ATTACHMENT A

EXISTING TECHNICAL SPECIFICATIONS AND BASES  
UNIT 3

**ATTACHMENT B**

PROPOSED TECHNICAL SPECIFICATIONS AND BASES  
UNIT 3

FIGURE 3.4-2

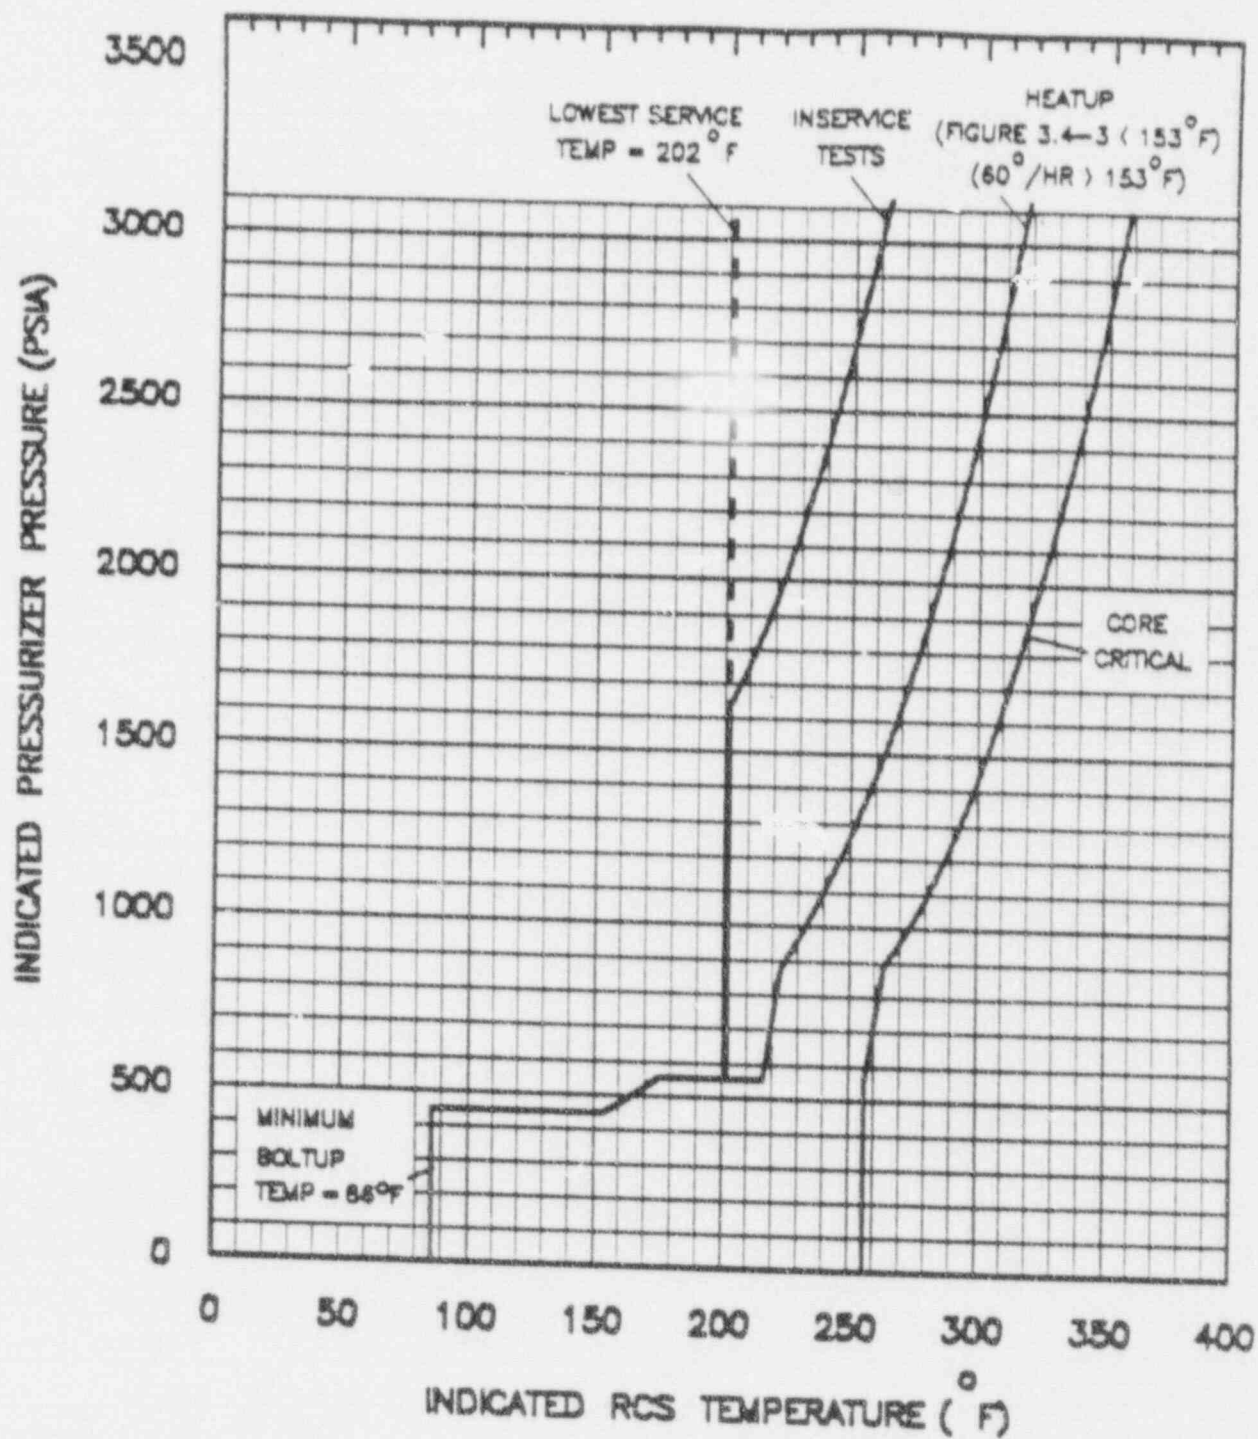
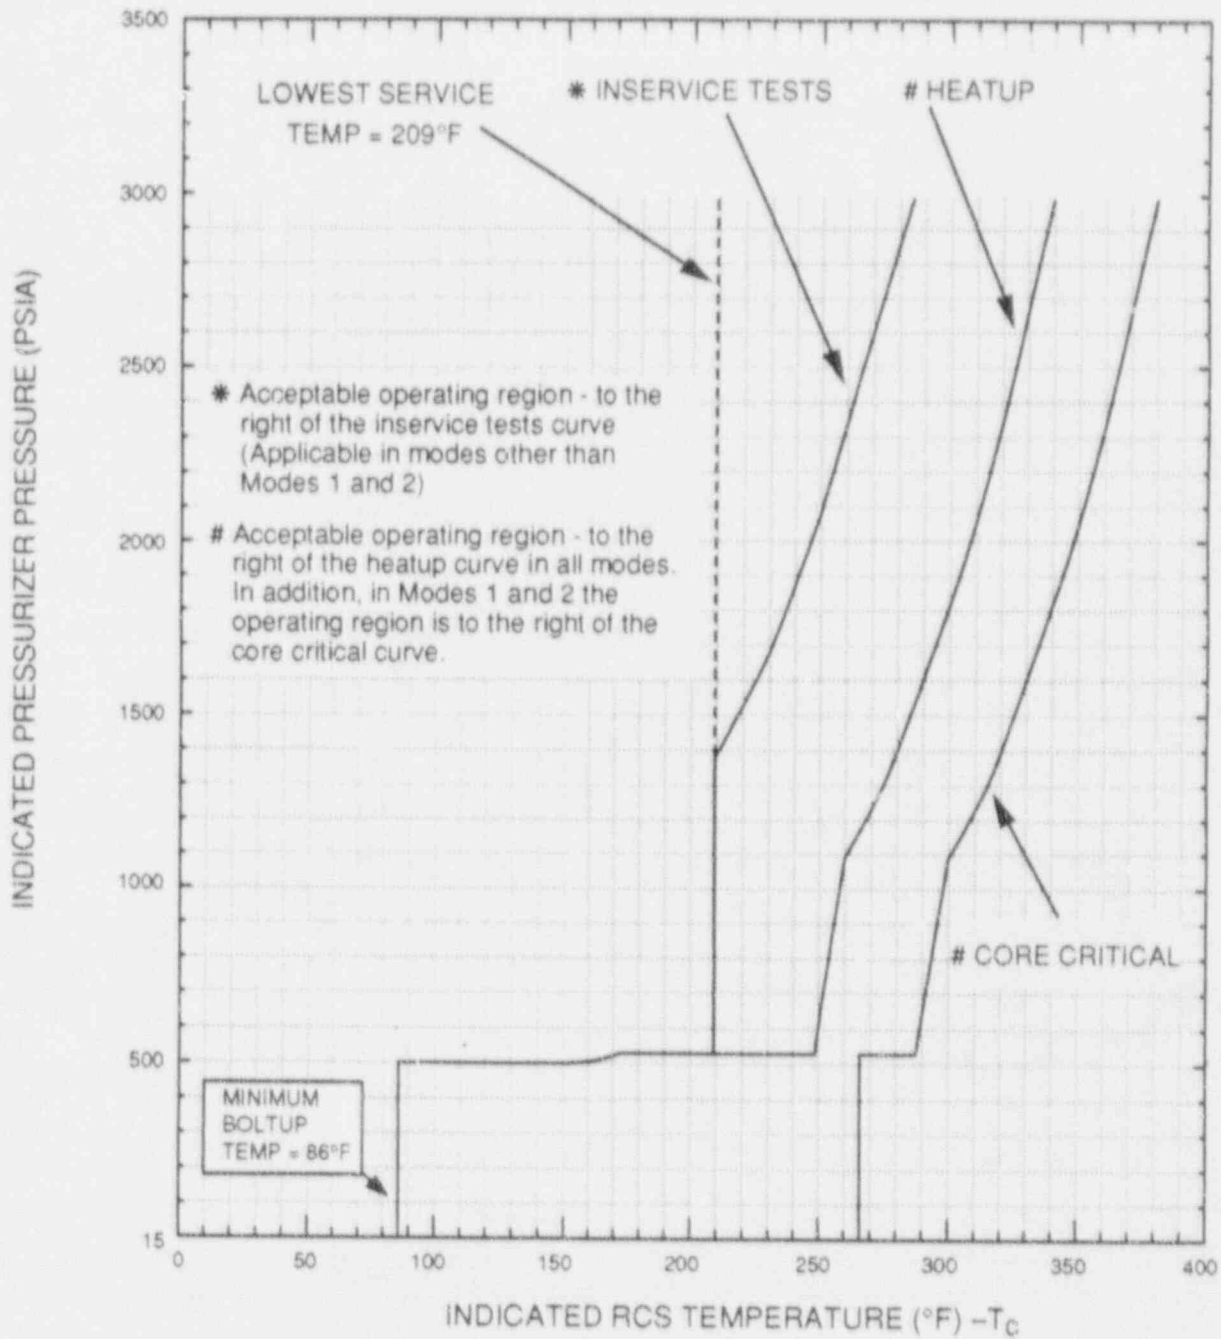
3.4-2 SONGS 3 HEATUP RCS PRESSURE/TEMPERATURE LIMITATIONS FOR <del>0-5 YEARS</del> UNTIL 20 EFY-NORMAL OPERATION.....	3/4 4-30   sup2
3.4-3 <del>COOLDOWN RCS PRESSURE/TEMPERATURE LIMITATIONS FOR 0-5 YEARS DELETED.....</del>	<del>3/4 4-30a</del>

SONGS 3 HEATUP RCS PRESSURE/TEMPERATURE  
LIMITATIONS FOR 4-8 UNTIL 20 EPY  
Normal Operation

FIGURE 3.4-3

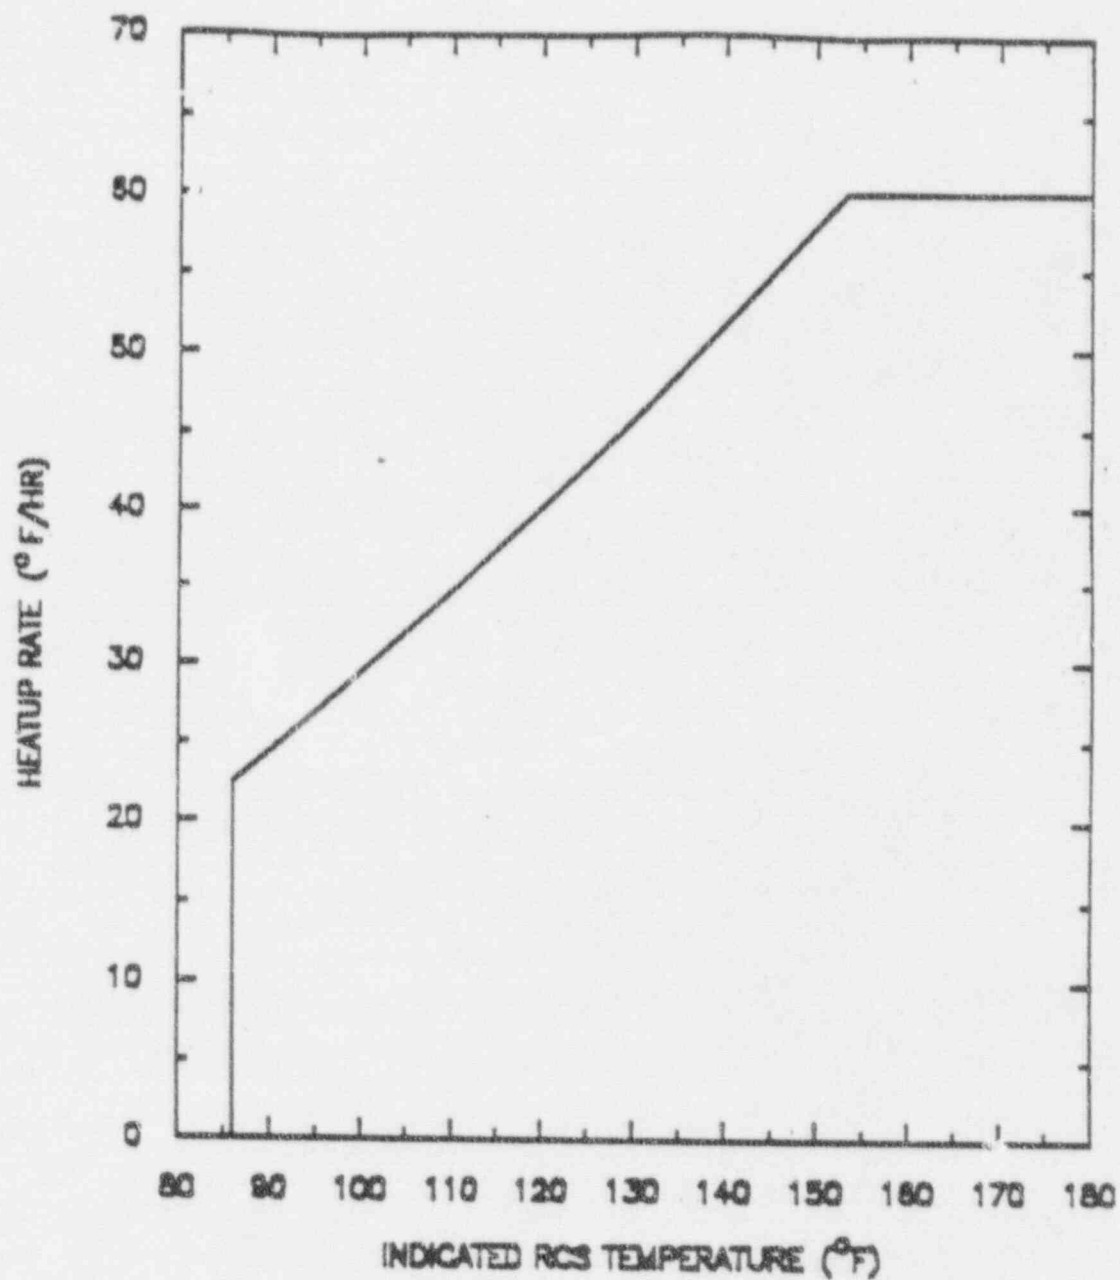
- a. ~~A maximum heatup as specified by Figure 3.4-3 in any 1-hour period with RCS cold leg temperature less than 153°F. A maximum heatup of 60°F in any 1-hour period with RCS cold leg temperature greater than 153° or equal to 86° F.~~ | sup 2

(Figure 3.4-3 - DELETED)

FIGURE 3.4-4

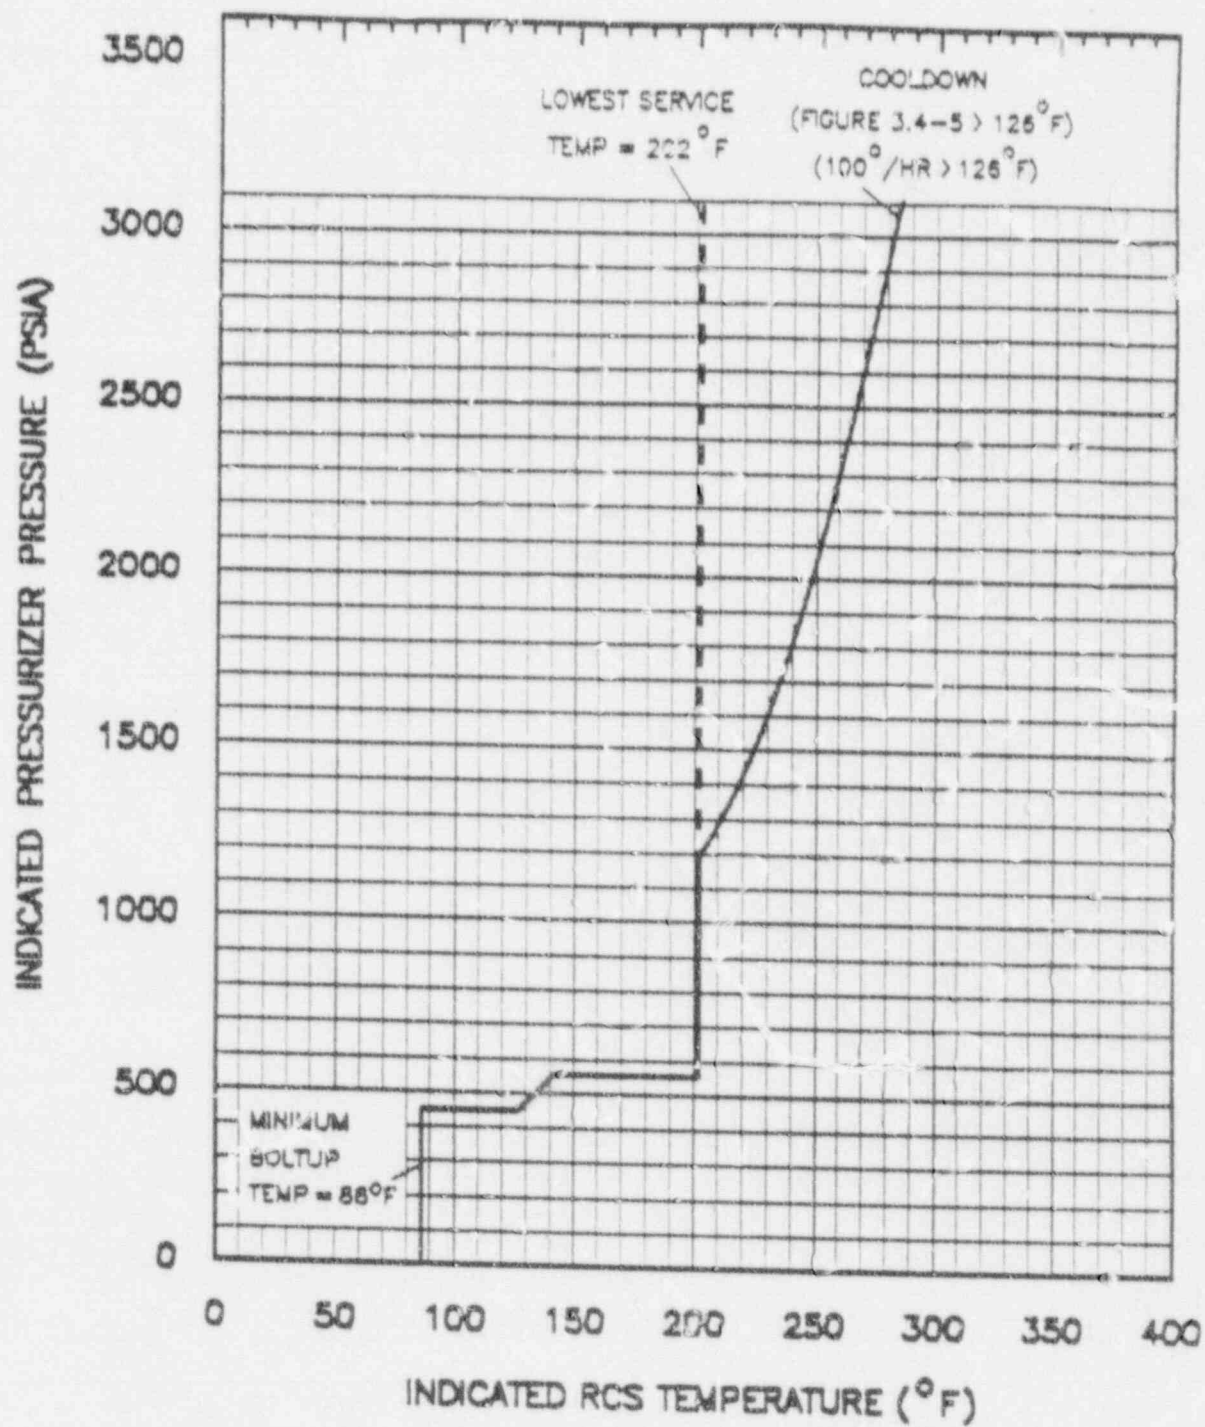
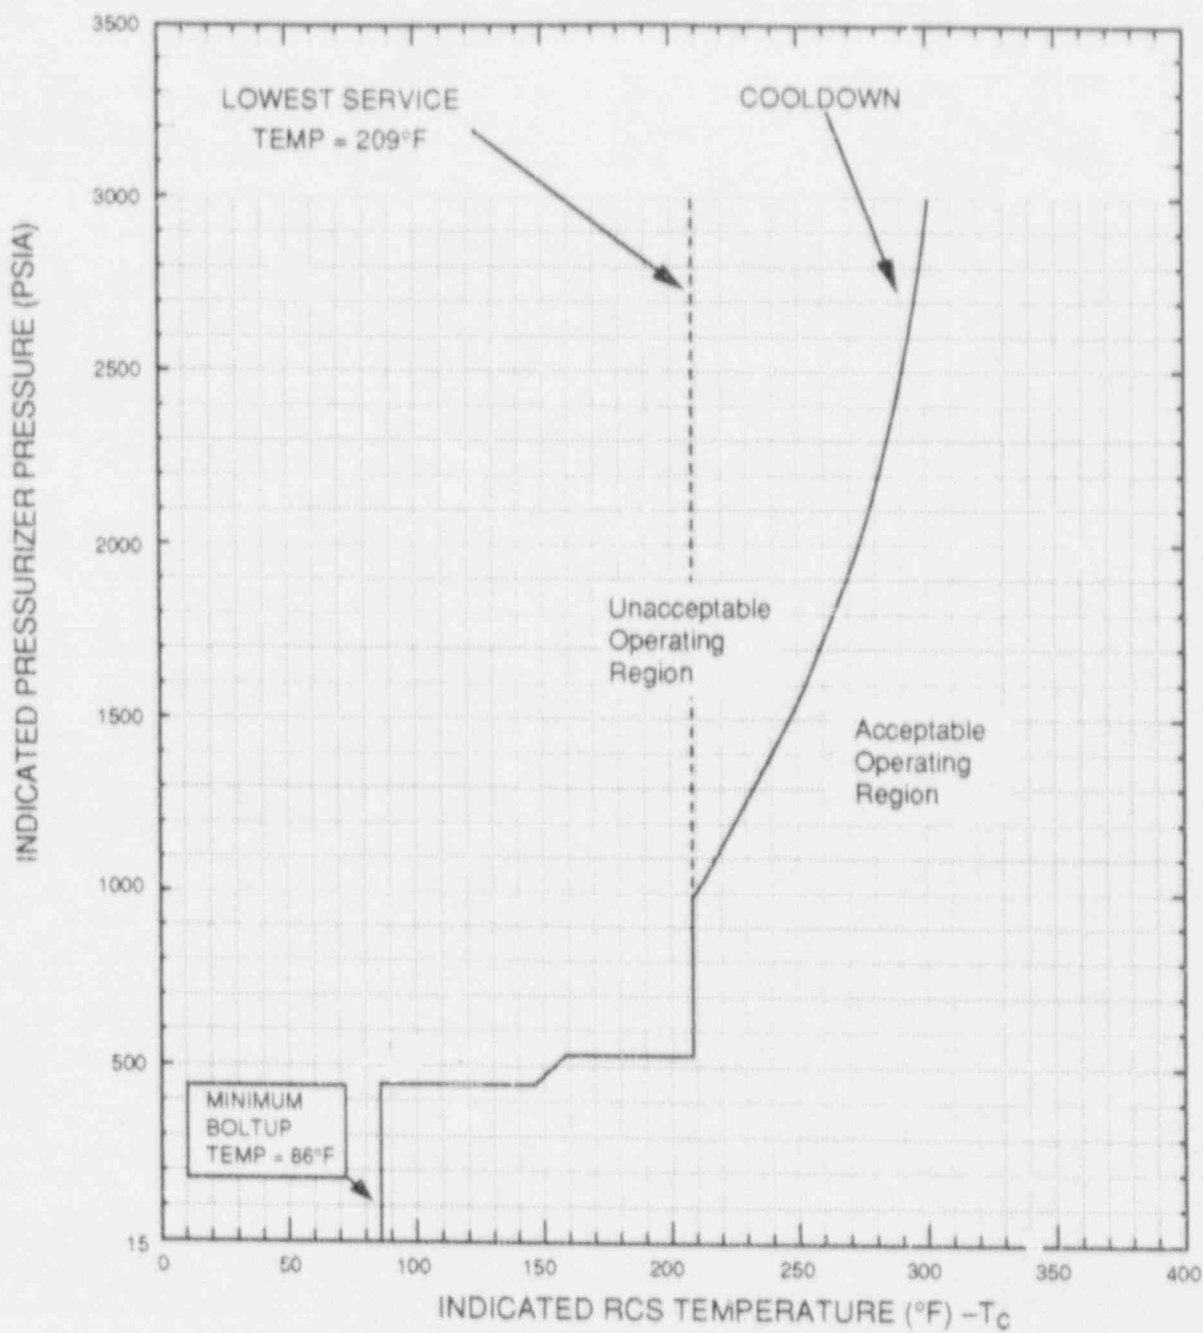
3.4-4 SONGS 3 COOLDOWN RCS PRESSURE/TEMPERATURE LIMITATIONS FOR <del>4-8</del> UNTIL 20 EFY-NORMAL OPERATION.....	3/4 4-31   sup2
3.4-5 SONGS 3 RCS PRESSURE/TEMPERATURE LIMITS MAXIMUM ALLOWABLE COOLDOWN RATES ( <del>4-8</del> UNTIL 20 EFY)-NORMAL OPERATION.....	3/4 4-31a   sup2

SONGS 3 COOLDOWN RCS PRESSURE/TEMPERATURE  
LIMITATIONS FOR 4-8 UNTIL 20 EPY  
Normal Operation

FIGURE 3.4-5

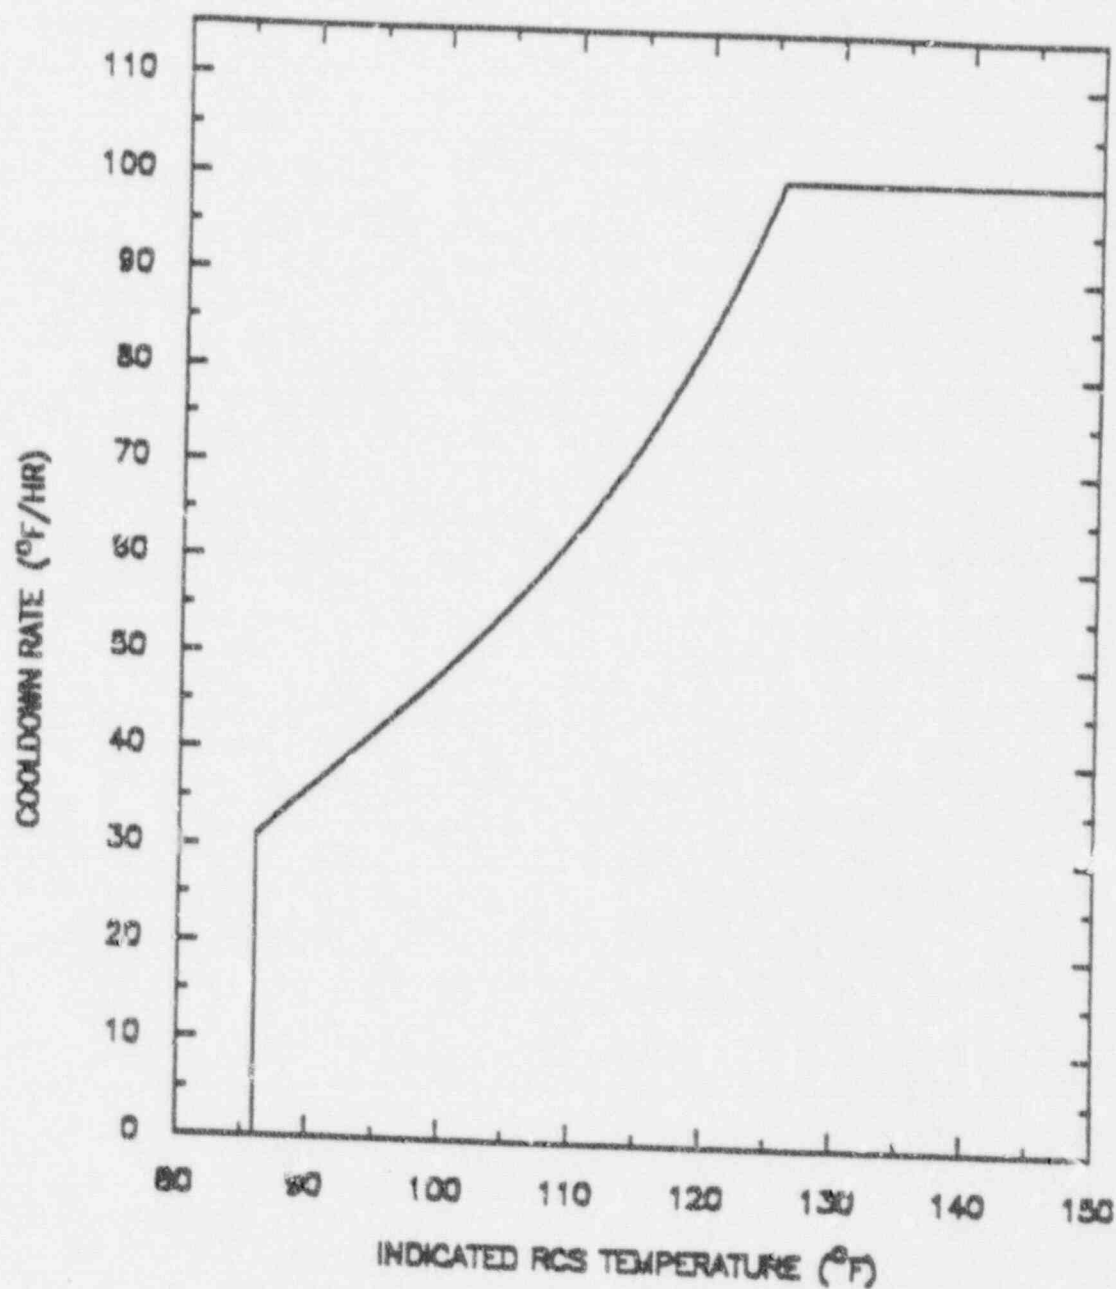
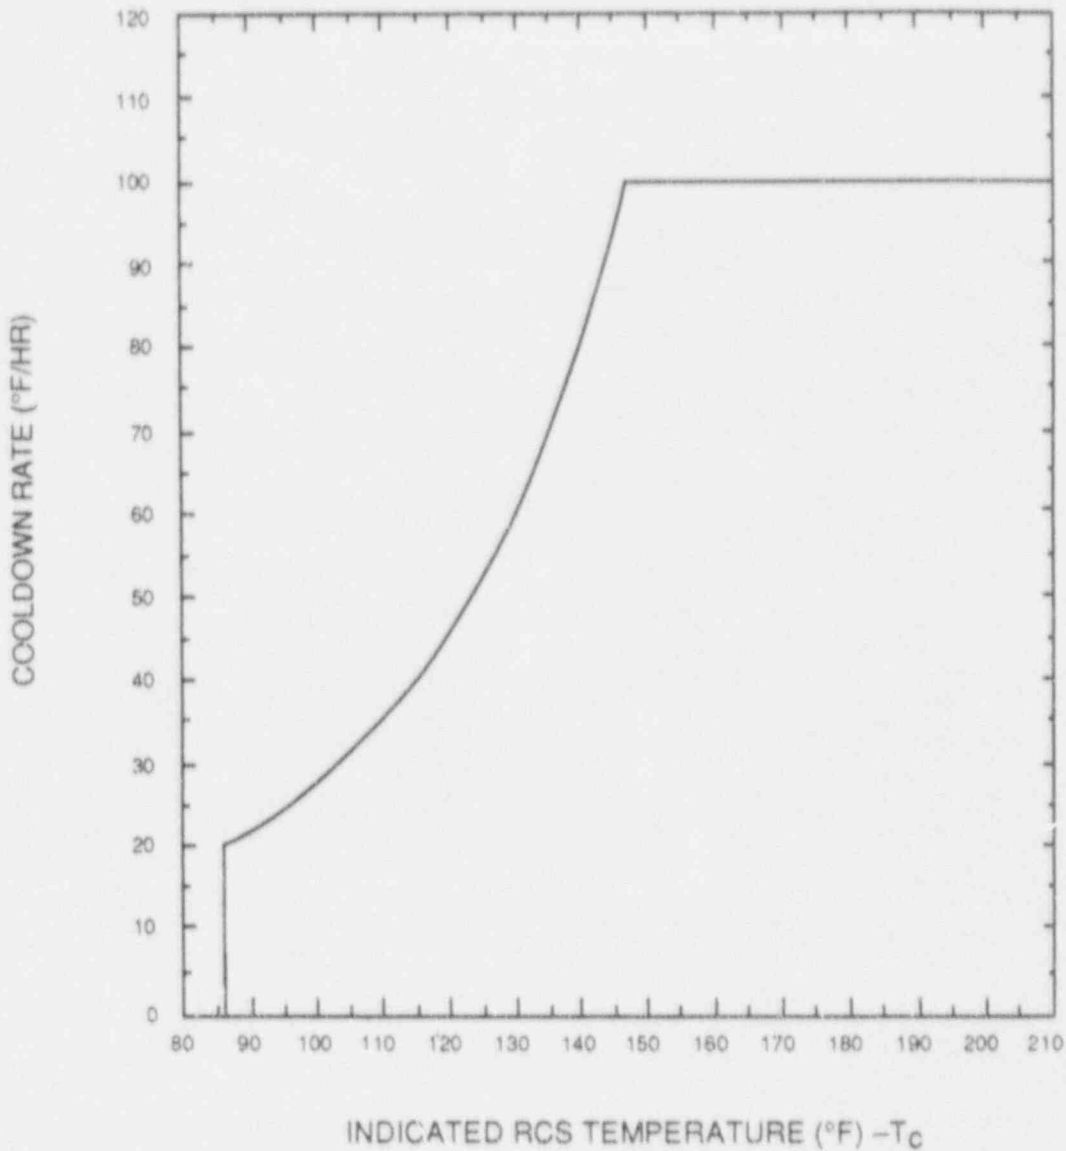
- b. A maximum cooldown as specified by Figure 3.4-5 in any 1-hour period with RCS cold leg temperature less than ~~126~~ or equal to 147°F. A maximum cooldown of 100°F in any 1-hour period with RCS cold leg temperature greater than ~~126~~ 147°F. | sup 2

NOTE: A MAXIMUM COOLDOWN RATE OF 100°F/HR IS ALLOWED  
AT ANY TEMPERATURE ABOVE 147°F

SONGS 3 RCS PRESSURE/TEMPERATURE LIMITS  
MAXIMUM ALLOWABLE COOLDOWN RATES (—4-8 UNTIL 20 EFY)  
Normal Operation
